November 7, 2024

ADDENDUM NO. 01 to the plans and specifications for MACOMB COUNTY – COUNTY WAREHOUSE – F & O AND PURCHASING OFFICE RENOVATION, CLINTON TOWNSHIP, MI, Architect’s Project No. 242053, dated OCTOBER 31, 2024

PLUMBING DEMOLITION FIRST FLOOR PLAN
SCALE: 1/8" = 1'-0"

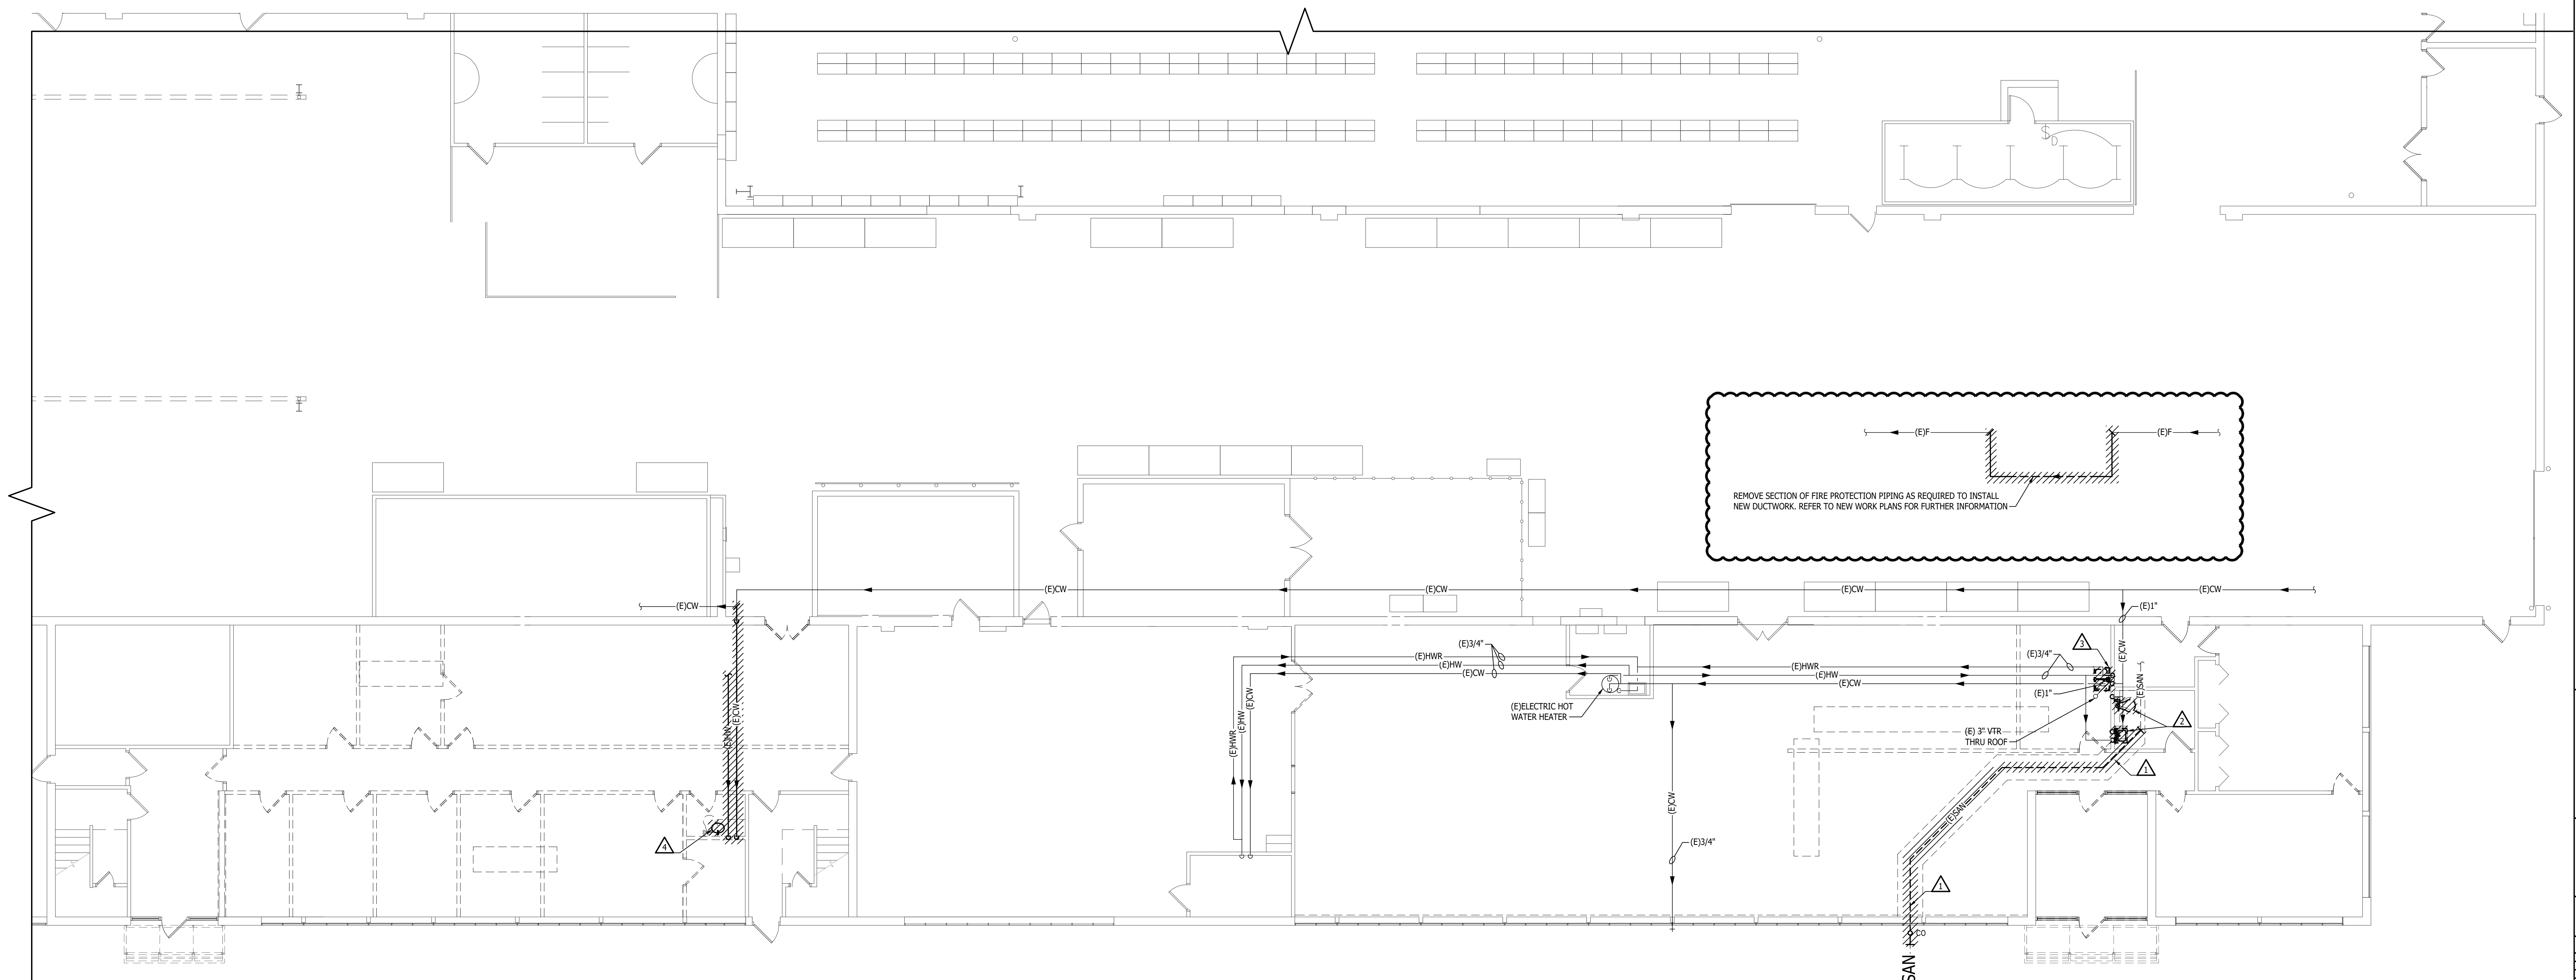
1. Adjusted Project number on plans as indicated.
- ITEM NO. M3:** Refer to sheet PD1.10 – Plumbing Demolition First Floor Plan (Re-issued);
1. Adjusted Project number on plans as indicated.

2. Added scope to re-work fire protection main in warehouse space.
- ITEM NO. M4:** Refer to sheet MD1.10 – Mechanical Demolition First Floor Plan (Re-issued);

PLUMBING NEW WORK FIRST FLOOR PLAN
SCALE: 1/8" = 1'-0"

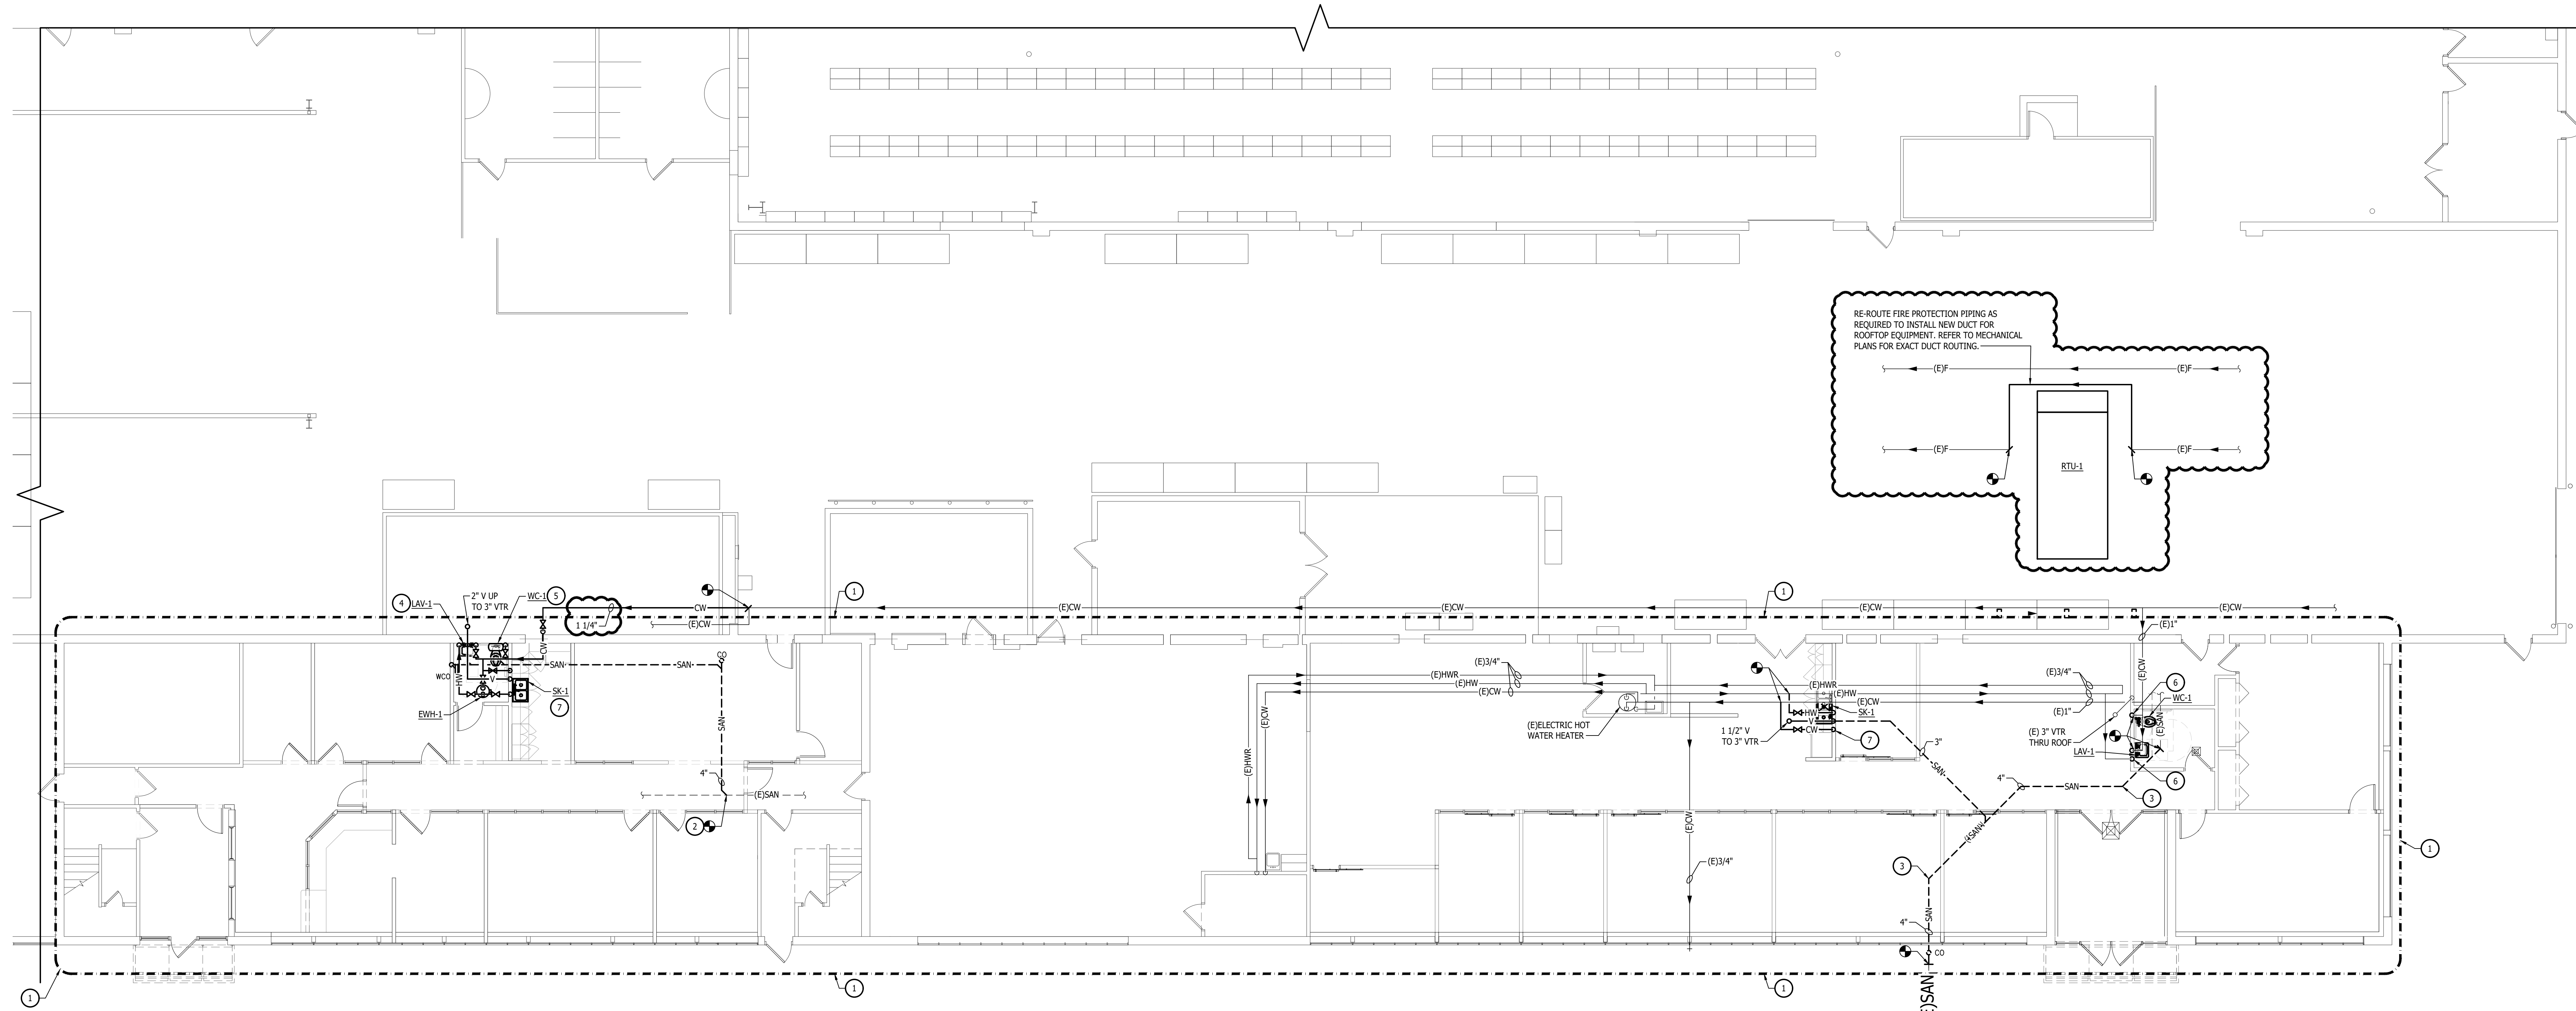
- ITEM NO. M6:** Refer to sheet P1.10 – Plumbing New Work First Floor Plan (Re-issued);
1. Adjusted Project number on plans as indicated.
2. Added cold water piping size to plan as indicated.

3. Added scope to re-route fire protection main as required to install new ductwork.

MECHANICAL NEW WORK FIRST FLOOR PLAN
SCALE: 1/8" = 1'-0"

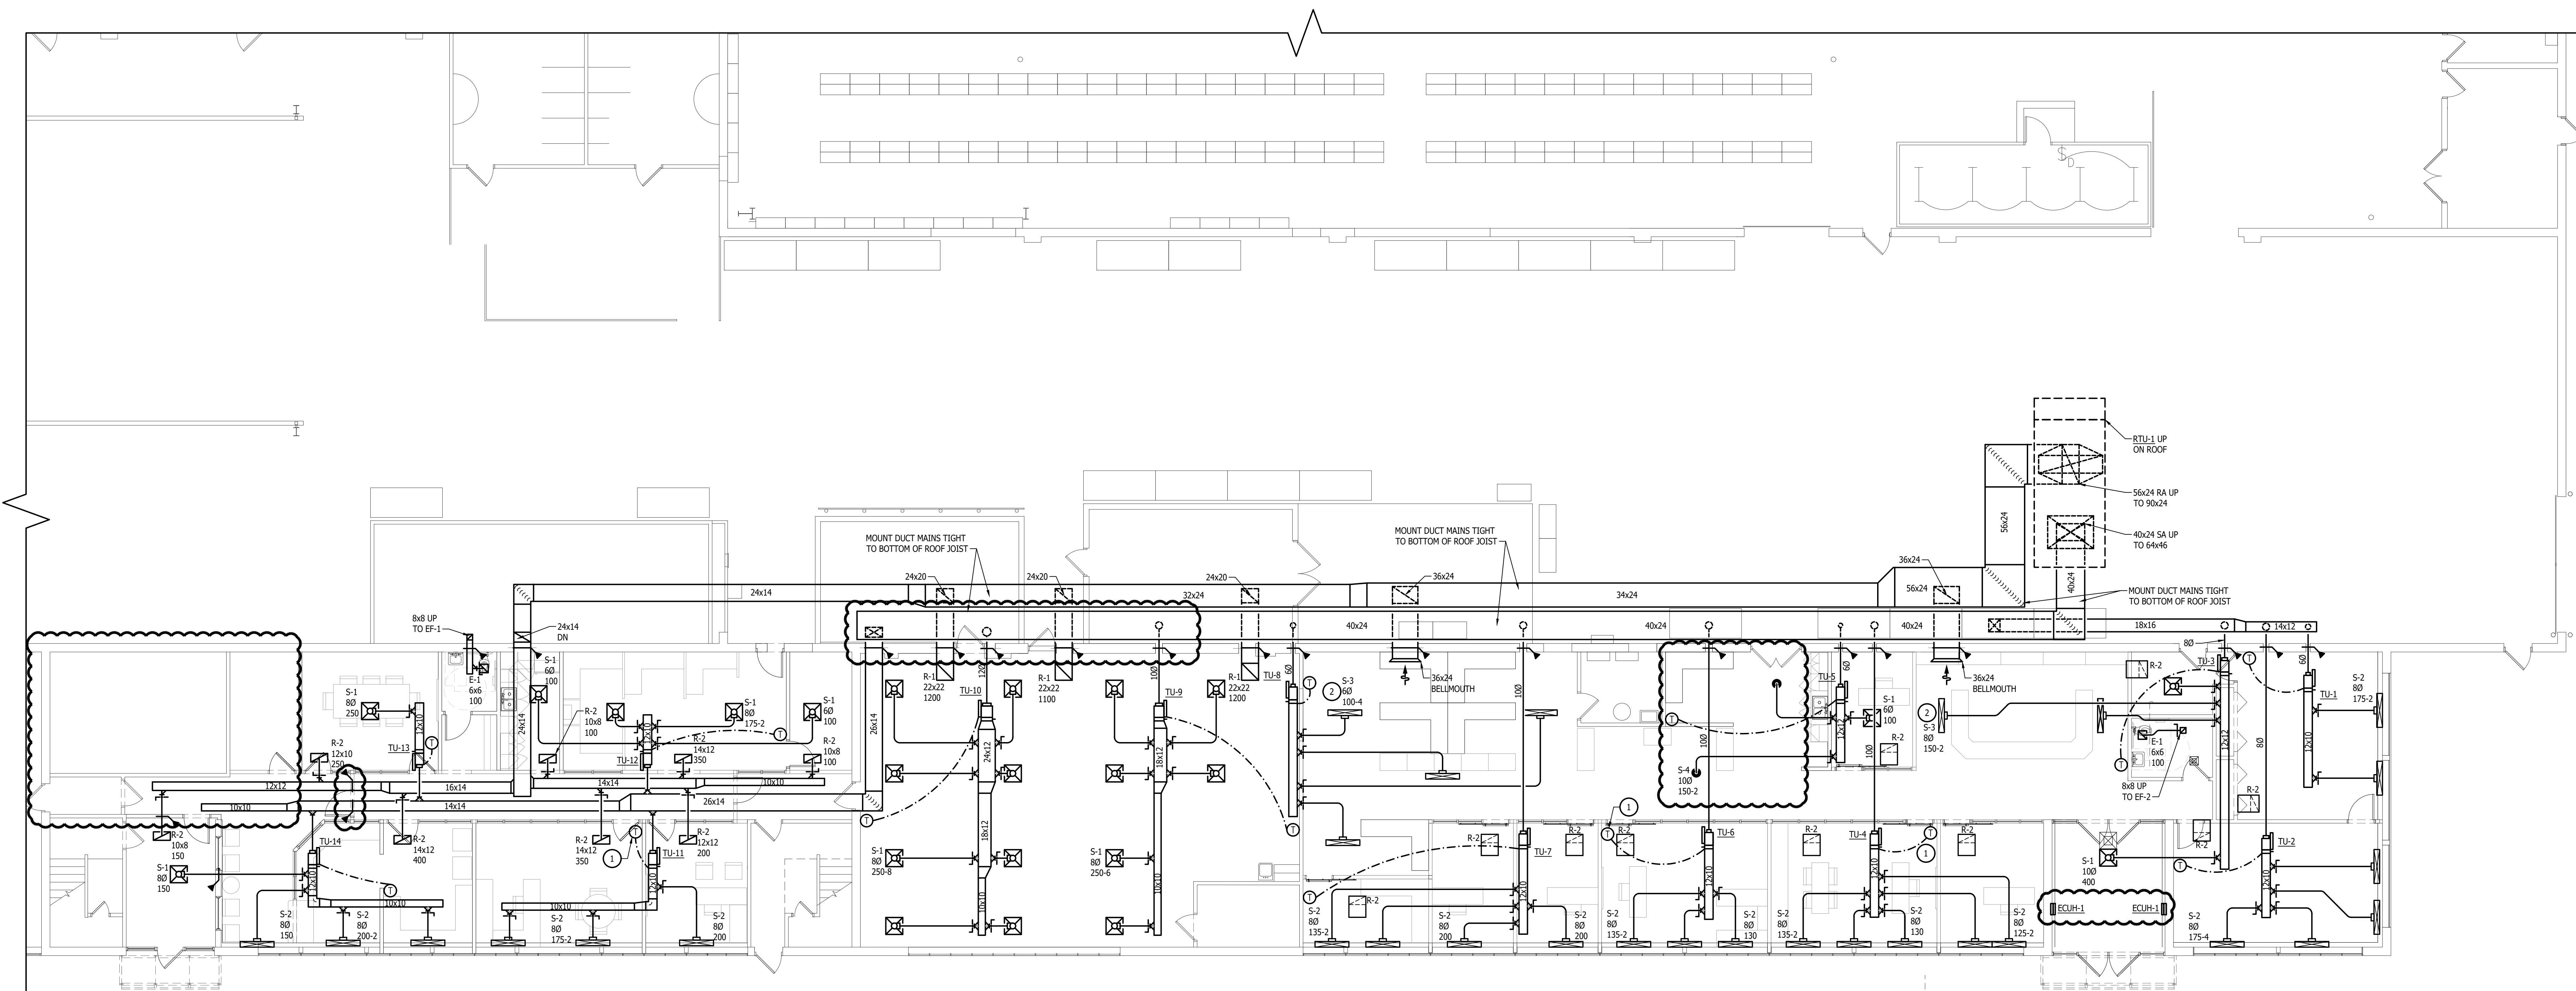
- ITEM NO. M7:** Refer to sheet M1.10 – Mechanical New Work First Floor Plan (Re-issued);
1. Adjusted Project number on plans as indicated.
 2. Removed terminal unit #15

3. Removed diffuser serving IT space
 4. Added fire dampers at location shown
 5. Adjusted diffuser layout to accommodate Architectural ceiling elements.

6. Extended 40"x24" duct as indicated
- ITEM NO. M8:** Refer to sheet M2.10 – Mechanical New Work First Floor Plan (Re-issued);
1. Adjusted Project number on plans as indicated.

MECHANICAL NEW WORK ROOF PLAN
SCALE: 1/8" = 1'-0"

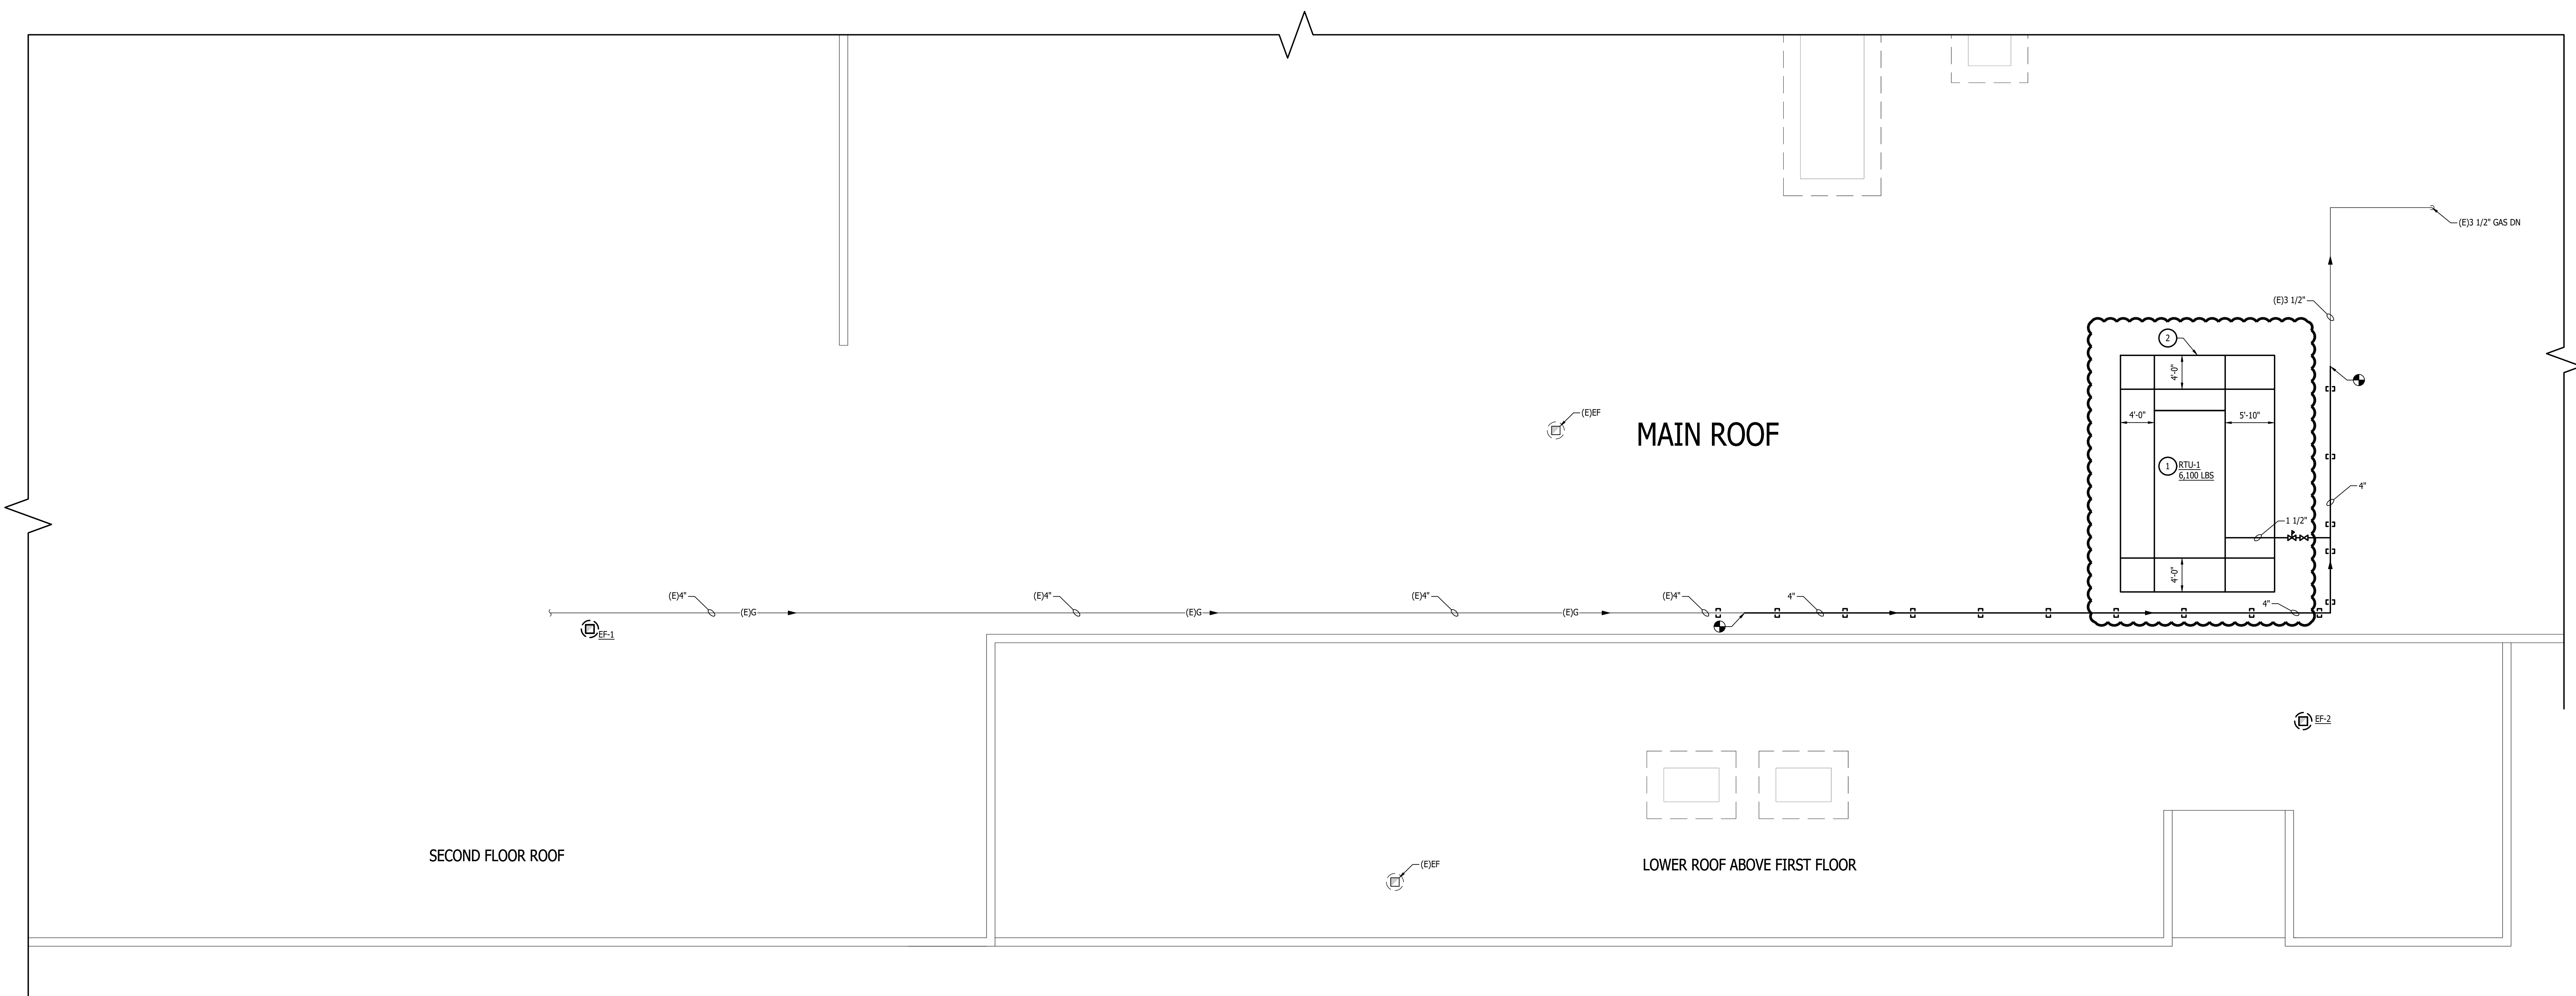
2. Added keyed note #2
 3. Added rooftop unit mounted screening to unit.
- ITEM NO. M9:** Refer to sheet M5.00 – Mechanical Details (Re-issued);
1. Adjusted Project number on plans as indicated.
